**To** Wayland Zoning Board of Appeals

**From:** John Sax - President of the Willow Brook Condominium Association

**Subject: Comments on the Weston and Sampson February 26 2019 submission to the ZBA on 198-501.2 and 198-606.2 compliance for the Loker turf field project (ZBA case 18-27).**

Figure 1

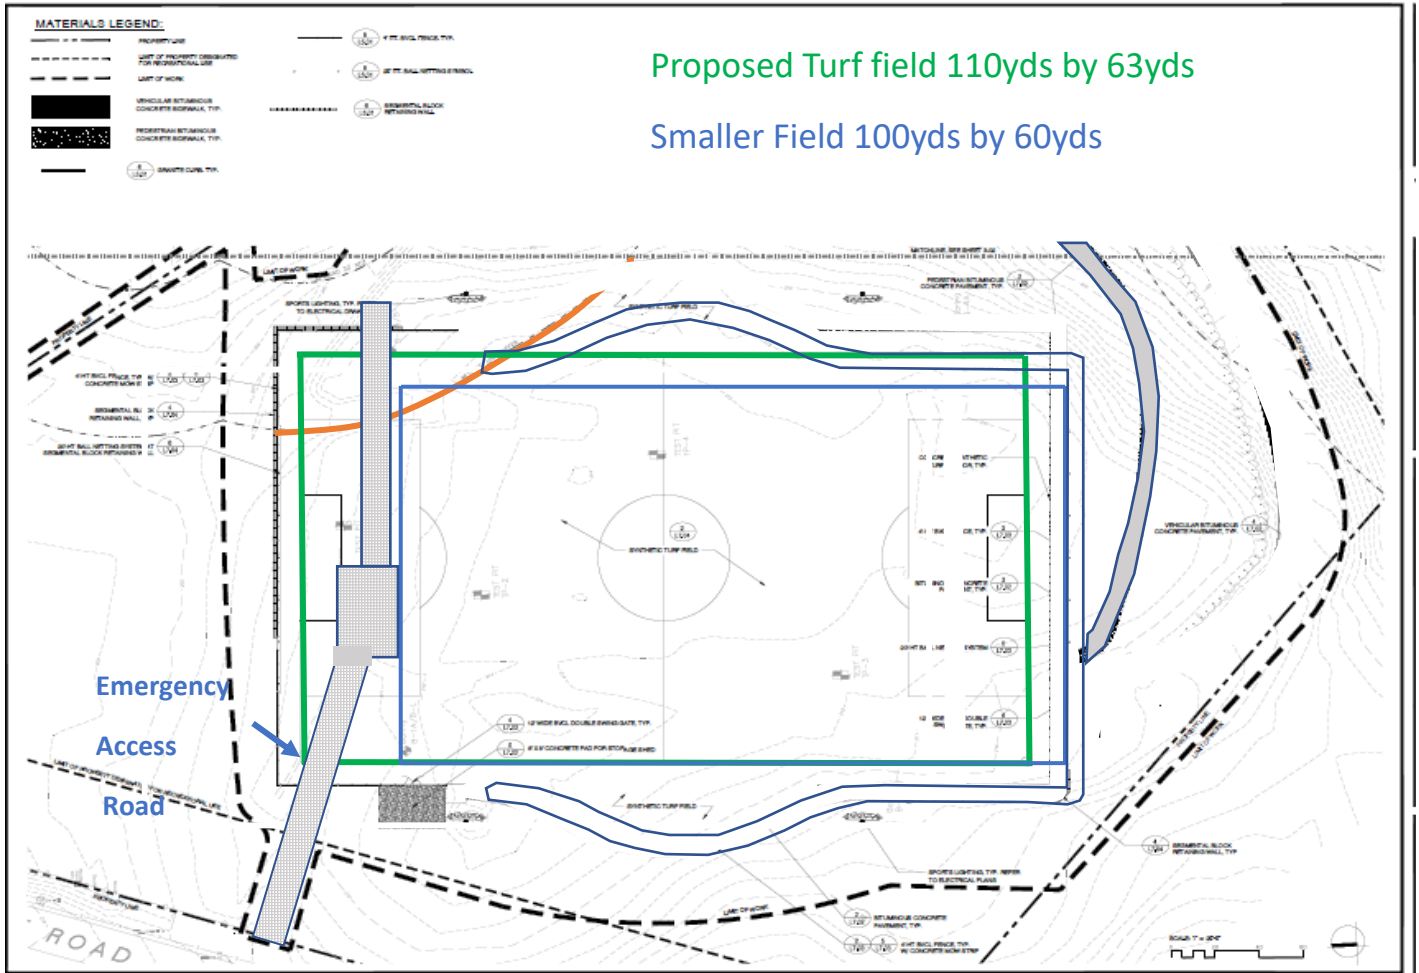
The most important limit the ZBA could impose is a smaller standard field size. The proposed field size of 110 yards by 63 yards does not conform to a standard soccer field size for any age group. It is simply the field size that will fit at Loker without impinging on the no-go zone of the conservation land. The proposed dimensions are closest to the 91 meters by 55 meters (99.518 yards 60.148 yards) for the U15/U16 age group. Reducing the proposed field size to the standard for U15/U16 age group size would significantly reduce the adverse impact of the project (see map in figure 1). Specifically, it would:

The proposed dimensions are closest to the 91 meters by 55 meters for the U15/U16 age group. Reducing the proposed field size to the standard for U15/U16 age groups would significantly reduce the adverse impact of the project (see map in figure 1).

**As shown on the map in Figure 1 a smaller field would allow the use of the Rice Road exit for emergency vehicles. That would eliminate the possibility of cars and pedestrians blocking access to emergency vehicles.**

Figure 3

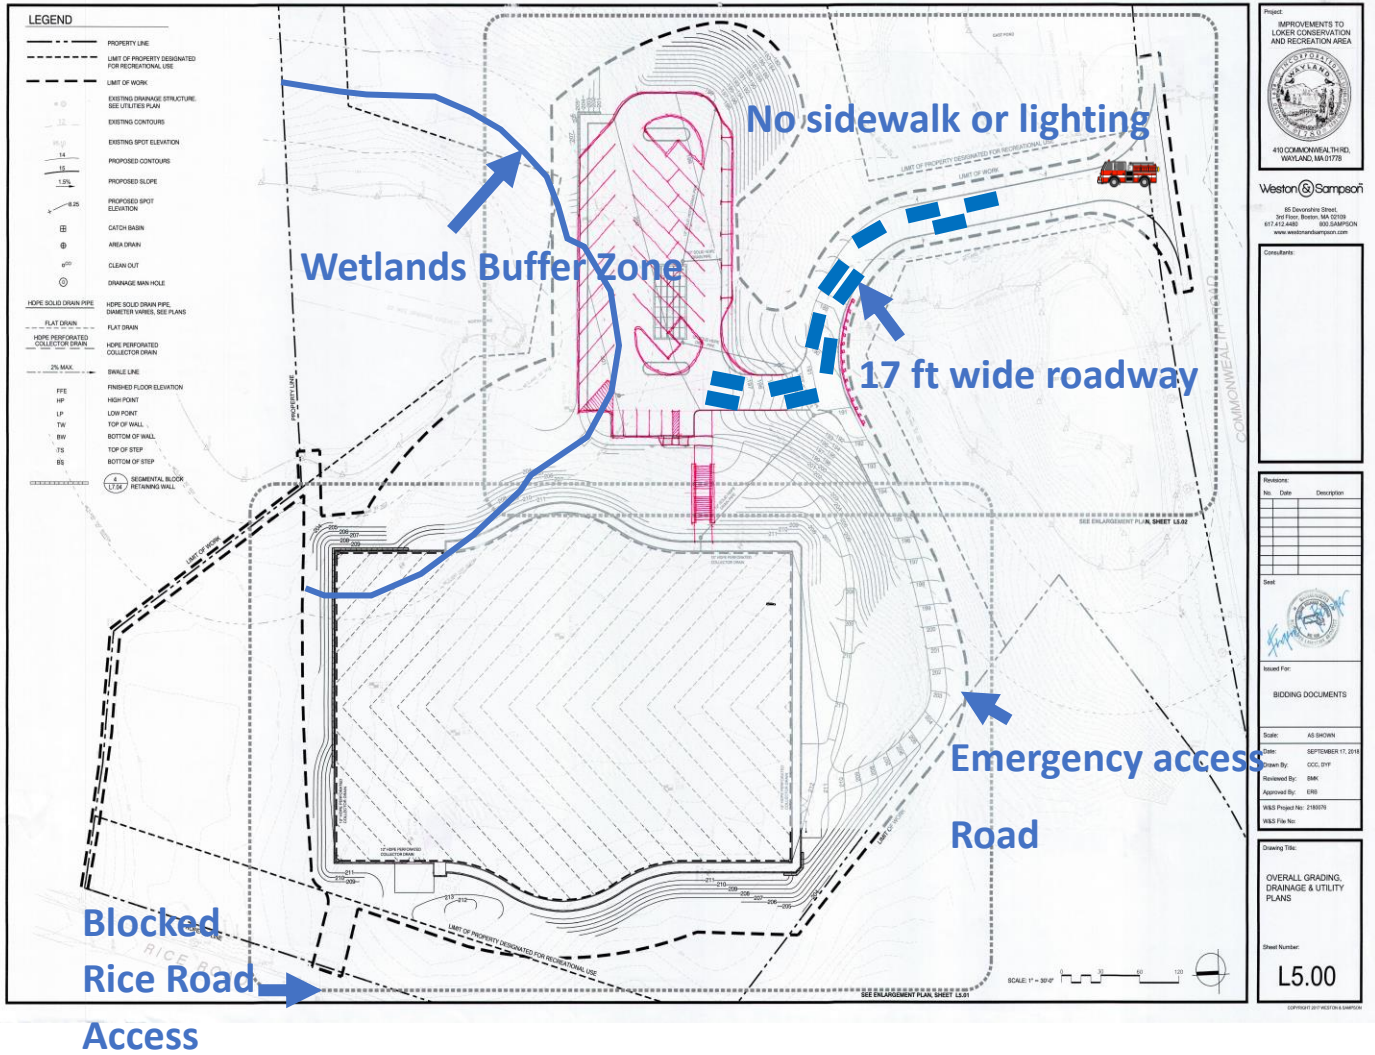
As shown in the picture in figures 2 and 3 the access road is barely wide enough for two cars and would not accommodate two-way traffic if one of the vehicles is a bus, minibus, ambulance or fire truck. The narrow winding access road will force cars to move very slowly to and from the parking lot. This will result in a significant backup on the access road during peak traffic periods. In addition, drivers coming from the west on Commonwealth Avenue will have to cross a lane of rush hour traffic to pull into the access road. Since cars will come in clusters around game time, traffic will back up on Commonwealth Avenue as Loker bound cars wait to enter the congested access road. The speed of east-moving traffic on Commonwealth Avenue will approach the speed of cars moving up the access road to the parking lot.

**As shown in figure 3, peak traffic congestion on the narrow access road will also make it very difficult for an emergency vehicle the size of an ambulance or a fire truck to reach the field or parking lot. There is not enough room for cars to pull over to the side on the access road to get out of the path of a firetruck or ambulance. To get out of the way cars would have to move to the parking lot assuming there is enough room there. Some cars moving down the road will have to back up the hill around a sharp turn to get out of the way. The confusion caused by children walking around on the unlit access road as drivers rush to make way for an emergency vehicle makes a serious accident a likely possibility.**
